Response to Questions and Issues

**Raised by Planning and Zoning Commission, Common Council, and nearby Property Owners
relating to Middletown Water Main and Water Storage Tank**

For Durham Meadows Superfund Site

October 2017

Appendix B – Individual Water Pressure Table Based on Water Tank (note that this table is no longer applicable due to decision to retain separate hydro-pneumatic system for Talcott Ridge Drive and Watch Hill Drive)

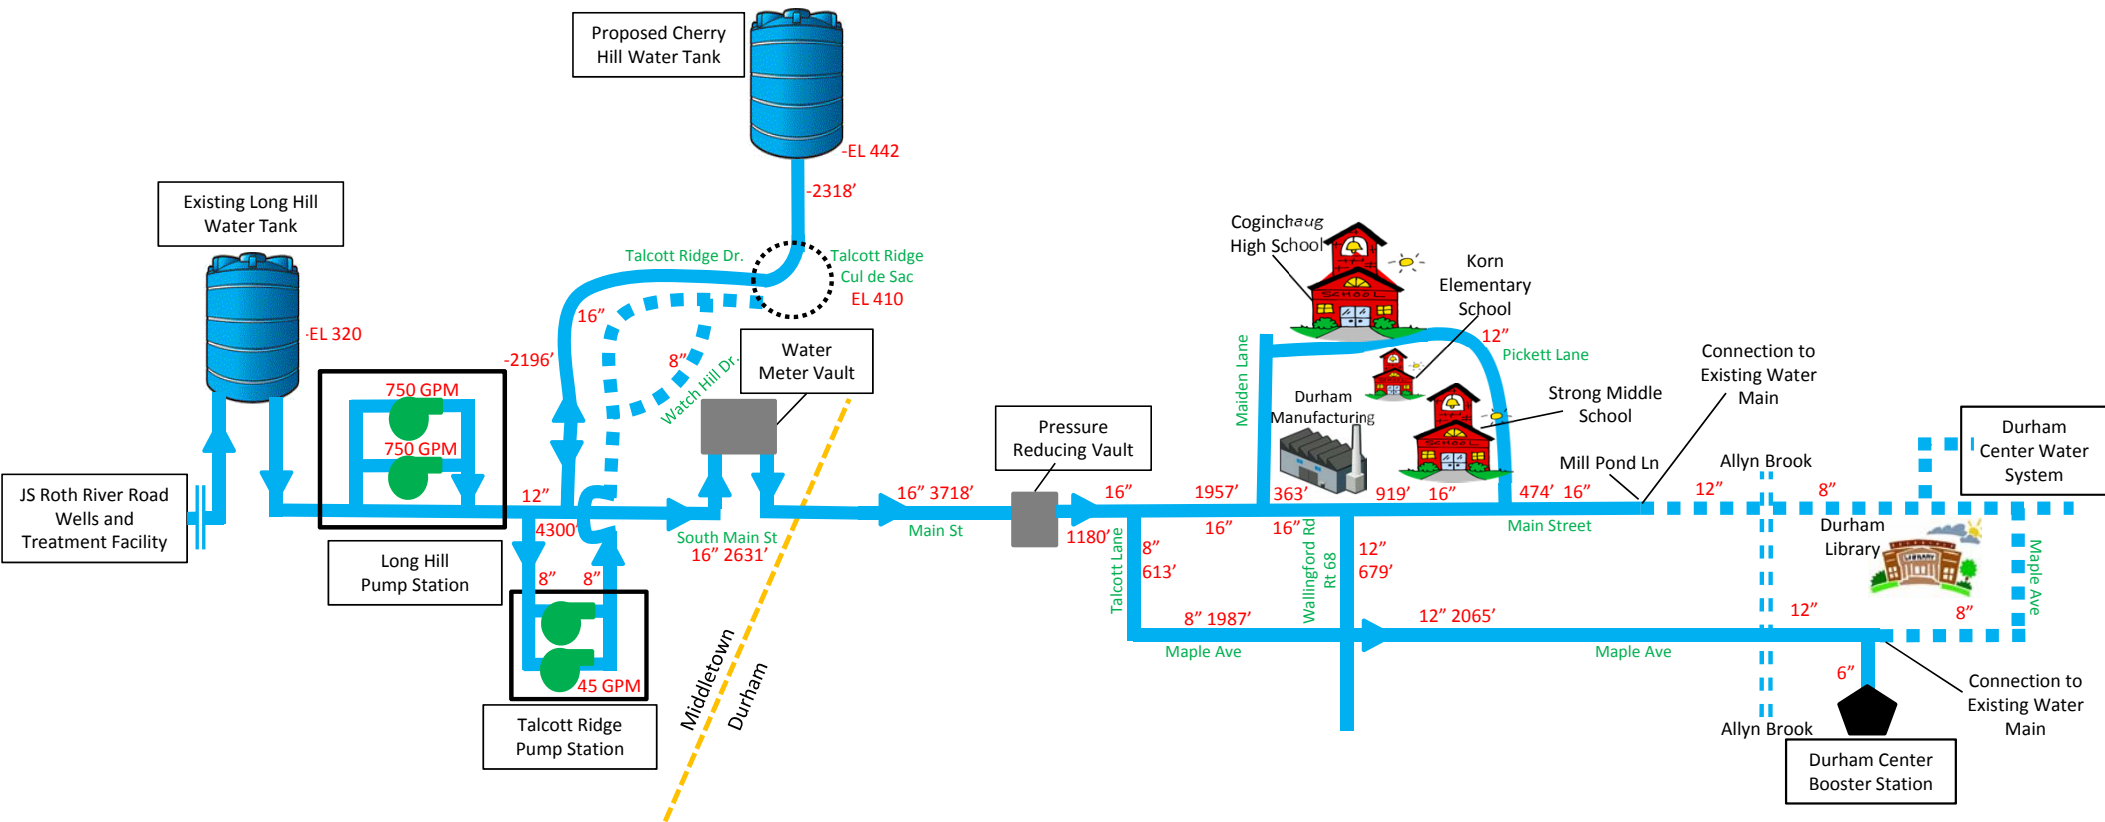
Summary of questions and issues: The input on this issue covered a broad range of topics. There was a request for a clear presentation of what the water pressure would be at each residence for both the first and second floor. A request was also made that the final water pressure numbers be checked by an independent entity. There were also numerous comments regarding the equity of the additional cost to maintain and eventually replace the booster pumps and why the existing system or a similar system could not provide for those properties where the need for a booster pump was identified.

Water pressure charts: In response to the comments provided by some of the property owners on Talcott Ridge Drive and Watch Hill Drive, EPA presented a table showing the approximate water pressure readings at the eight properties where booster pumps were recommended. The table was an attempt to provide clarity as to what the relative water pressure would be versus the current water pressure. This chart was not a part of the design and has been the subject of many comments. As discussed above, the specific water pressure at each residence is not the critical issue, rather the properties where a booster pump was recommended were 92 feet or less in elevation below the low daily water level in the water storage tank. Any property where the first floor is located more than 92 feet below the low daily water level in the tank would not need to have the water pressure estimated. The updated water pressure charts are attached as Appendix B. These charts are no longer applicable to the properties on Talcott Ridge Drive and Watch Hill Drive since they will not be served by the new water tank. While they have not been reviewed by an independent contractor, EPA requested that the United States Army Corps of Engineers review the charts. The attached charts have been reviewed by the USACE.

The charts present the water pressure at the water main, first floor, and second floor for each of the properties currently served by the Long Hill pump station. The elevation of the water main and first floor for each property was obtained from the City of Middletown geographic information system topographic maps. The second floor was assumed to be ten feet in elevation above the first floor. During normal operation, the water tank as currently designed is expected to operate within the top ten feet of the tank. For the water storage tank, three elevations are relevant for water pressure: 512 msl represents a full tank which should occur at the start of each day; 502 msl is the lowest level the tank should reach during normal demand days; and 491 msl is the lowest level the tank will be allowed to reach except when there is a fire. The 491 msl level should only be experienced during very high demand days (Durham Fair and additional high demand). The tank stores about 130,000 gallons from 502 msl to 513 msl. The design estimate for the expected demand from Durham and existing demand in Middletown is 90,000 gallons per day, which is within the capacity of the tanks up to 11 feet. As long as the Long Hill pump station is operational, the water level in the tank should very rarely drop below 502 msl.

WATER MAIN EXTENSION SCHEMATIC

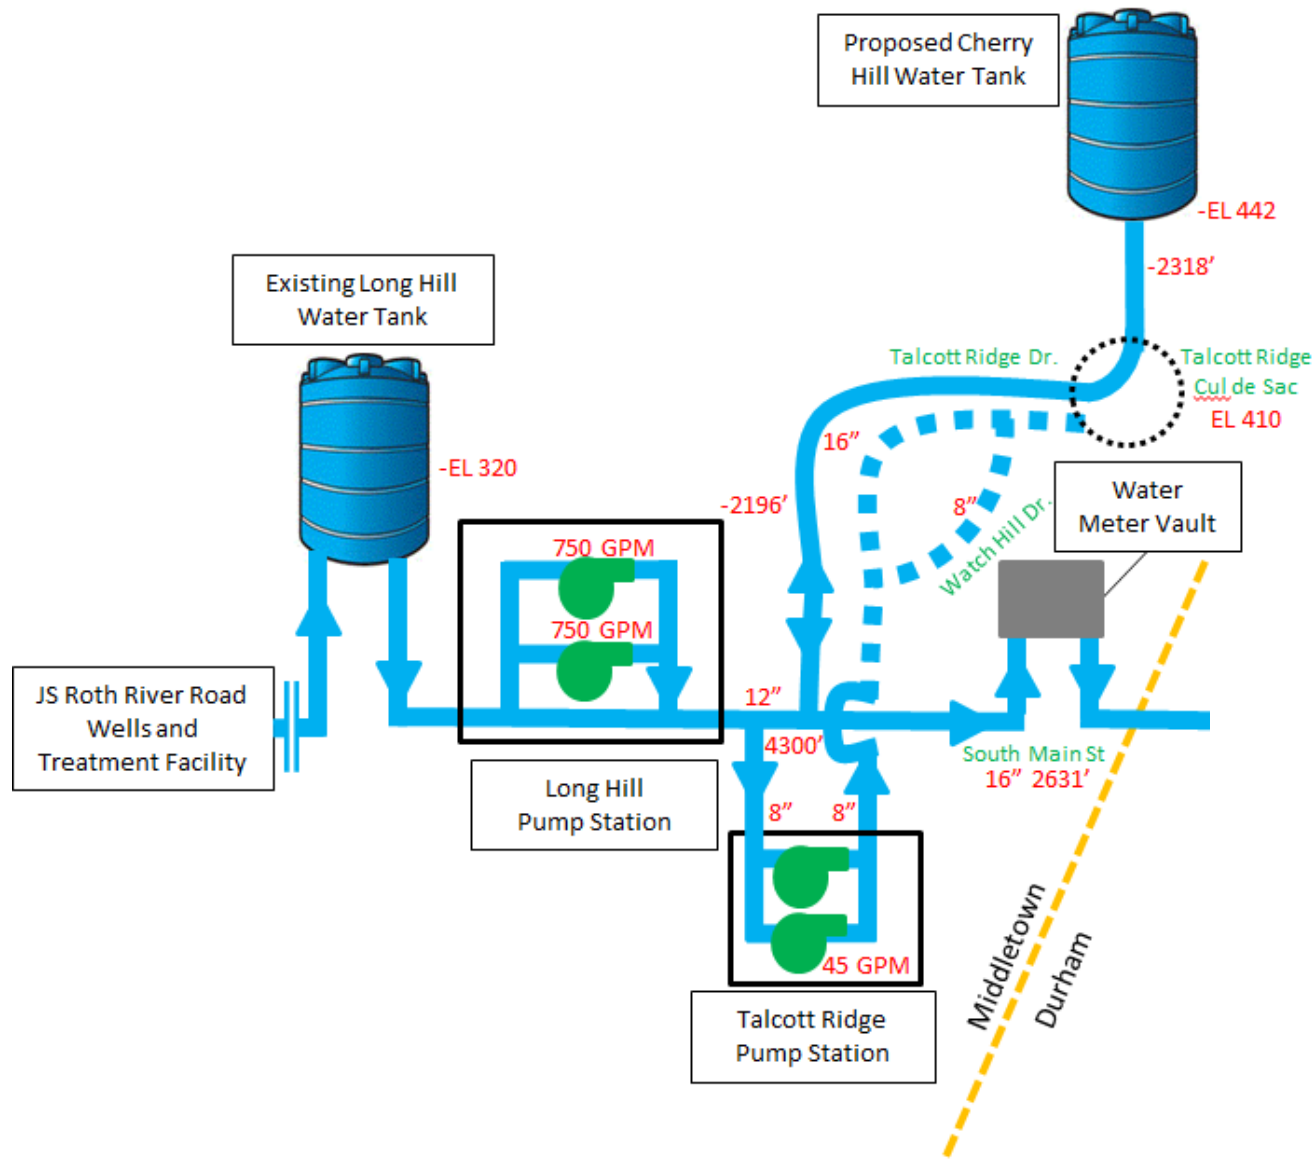
Summary of questions and issues: The comments requested an explanation as to why the new water storage tank could not be located at the site of the Long Hill tank or why the existing system could not provide the water to Durham. Other comments requested the daily demands in cubic feet and gallons and an explanation of the size of the tank. Another questioned why the project designers did not present alternative water tower designs. Comments also questioned why the existing system must be removed.

Response: The outcome of the re-evaluation of the project design based on the questions and issues is that individual booster pumps which were proposed to be installed inside the 8 residential properties are no longer included in the design. Property owners on Talcott Ridge Drive and Watch Hill Drive will be provided a separate hydro-pneumatic system that will be operated and maintained by the City of Middletown and will utilize as much of the existing infrastructure as possible. A conceptual schematic for the revised water main extension and separate hydro-pneumatic system is included as Appendix A.

Retain hydro-pneumatic system for Watch Hill Drive and Talcott Ridge Drive: The outcome of the re-evaluation is that the booster pumps which were proposed to be installed inside the 8 residential properties are no longer included in the design. Property owners on Talcott Ridge Drive and Watch Hill Drive will be provided a separate hydro-pneumatic system that will be operated and maintained by the City of Middletown and will utilize as much of the existing infrastructure as possible.
